PUBLIC ADVOCATES OFFICE

March 29, 2021

Subject: Comments of the Public Advocates Office on the 2021 Wildfire Mitigation Plan Updates of the Large Investor-Owned Utilities

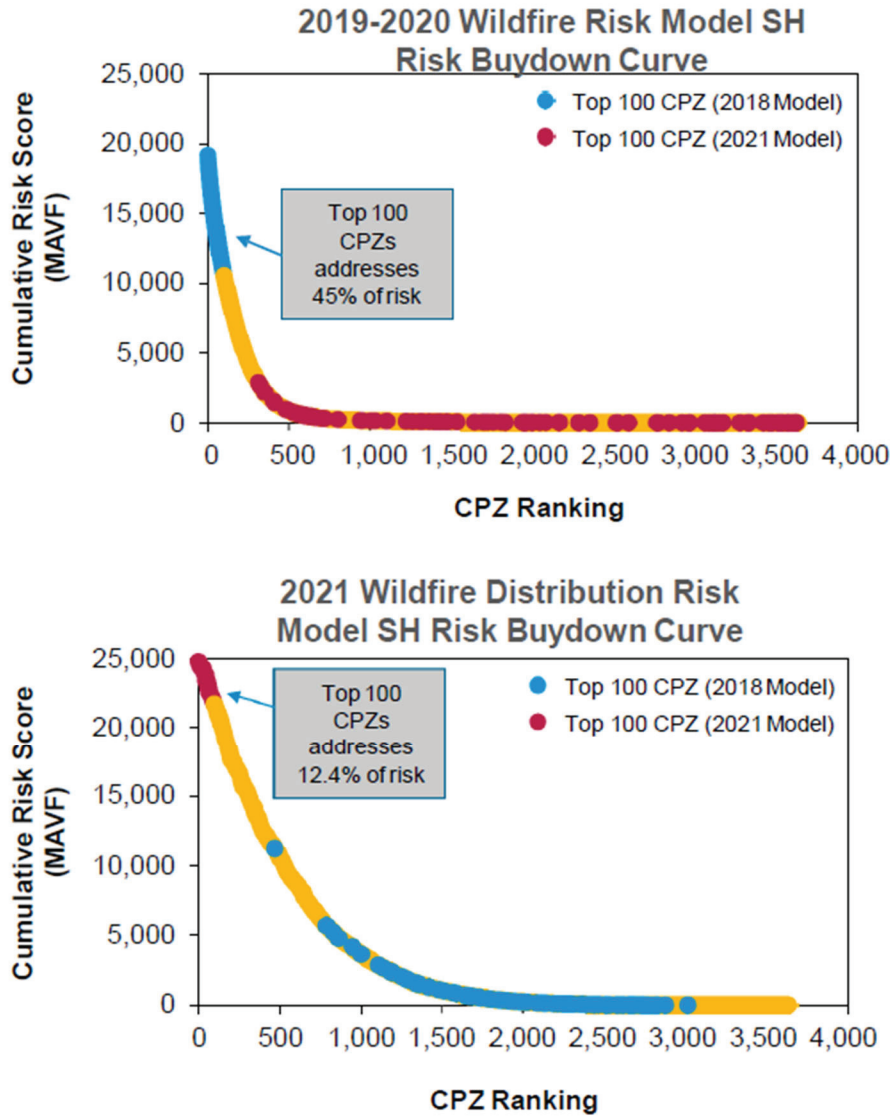
To demonstrate the difference in models, PG&E presented the following chart during the WSD workshop on grid design and system hardening held on February 23, 2021. The chart shows that the highest-risk circuit-segments under the new model were all ranked relatively low by the old model, and vice versa. Moreover, the shape of the curves is very different, which
